## 8.2.5 Individual Comments and Responses

**Table 8.2.5-5. Public Comment Documents Received**

**From:** [a345589144@fastmail.fm](mailto:a345589144@fastmail.fm)  
**To:** [Koutoufidis, Nicholas](#)  
**Subject:** [External] Re: Notice of Availability for the Draft EIR for the Starlight Solar Project (PDS2022-MUP-22-010)  
**Date:** Friday, August 1, 2025 7:46:22 AM

I4-11

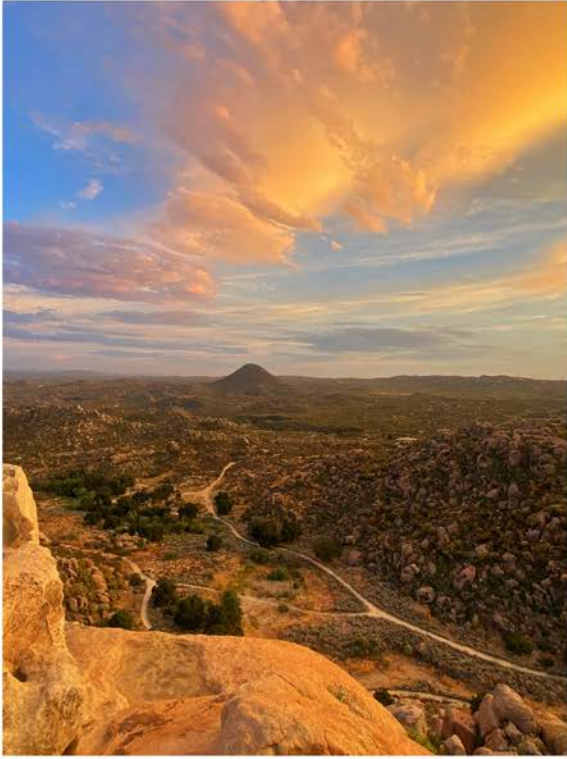
14-11	<p>The commenter includes a photograph of the project site.</p> <p>This is not a comment on the analysis contained in the EIR; therefore, a response is not required and no changes to the EIR were determined to be necessary in response to this comment.</p>
